## **Product Change Notice (PCN)**

PCN Number: PCN-0450965R-01

Product(s) Affected: MJ1-2503A

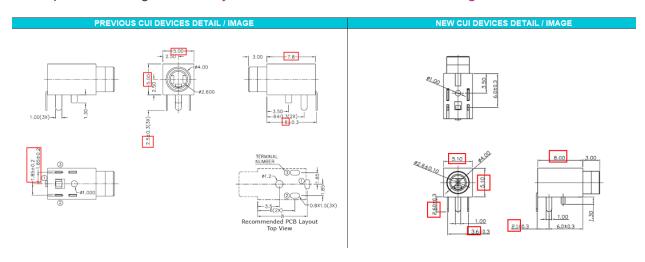
Description of Change: Minor Layout and Material Difference. See image Below

PREVIOUS CUI DEVICES DETAIL / IMAGE			NEW CUI DEVICES DETAIL / IMAGE			
			)	<b>®</b>		
	MATERIAL	PLATING	DESCRIPTION	MATERIAL	PLATING/COLOR	_
terminal 1	copper alloy	silver	terminal 1	bronze	silver	_
terminal 2	copper alloy	silver	terminal 2	bronze	silver	_
terminal 3	copper alloy	silver	terminal 3	bronze	silver	_
bushing	brass	nickel	bushing	brass	nickel	
plastic	PBT		housing	PBT (UL94V-0)	black	
-			<u> </u>	O
